PM5356

S/UNI-622-MAX

**SATURN
USER NETWORK INTERFACE
(622-MAX)**

REFERENCE DESIGN ERRATA

Figure 1 - Filtering for AVD<19>

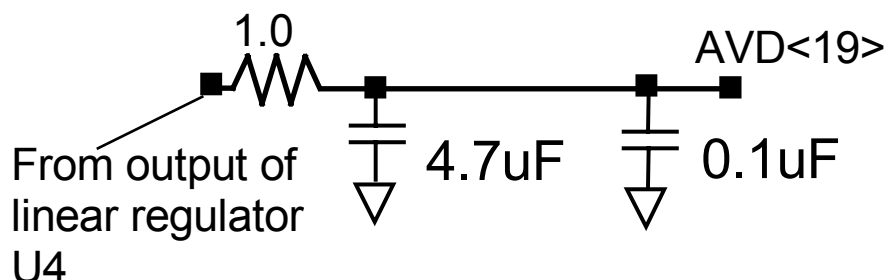
On Page 3 of the S/UNI-622-MAX Reference Design schematics, Pin 19 of AVD<31..0> is tied directly to the output of the linear voltage regulator (U4). This pin should be filtered with the circuit shown below. Without this filtering, jitter performance of the device will be degraded.
